# MANDATORY SERVICE BULLETIN

No. MSB-E4-022/4  
SUPERSEDES MSB-E4-022/3

Waste Gate Control Rod.

Engine type: E4  
Engine model(s): E4, E4P  
Serial number(s): all

Figure 4: Waste Gate Circlip

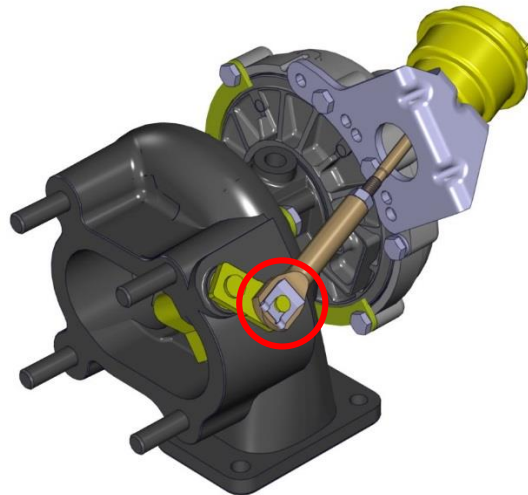
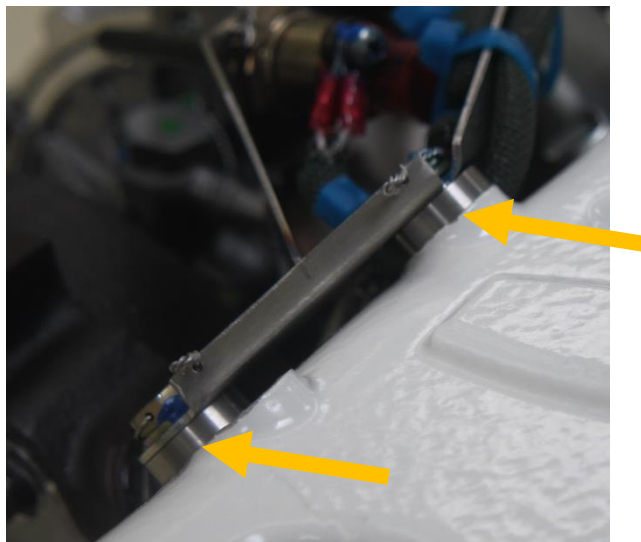
1. Make sure MM-TR-MDC-E4-386 and MM-TR-MDC-E4-399 are inserted into the Maintenance Manual or a revision of the Maintenance Manual with the Temporary Revisions incorporated is used.
2. Replace the waste gate controller according to Maintenance Manual section 81-00-33.
3. Install a new the spring loaded circlip E4A-41-100-801. Refer to figure 4

1. Replace the waste gate controller according to Maintenance Manual section 81-00-33.
2. Install a new the spring loaded circlip E4A-41-100-801. Refer to figure 4.

1. Make sure MM-TR-MDC-E4-422 is inserted into the Maintenance Manual or a revision of the Maintenance Manual with the Temporary Revisions incorporated is used.
2. If not yet installed, install a new spring loaded circlip E4A-41-100-801. Refer to figure 4.
3. Install the waste-gate con-rod fail-safe bridge according to Maintenance Manual section 81-00-36 or install a waste-gate controller with the fail-safe con-rod bridge already installed. Make sure there is sufficient clearance to adjacent parts.
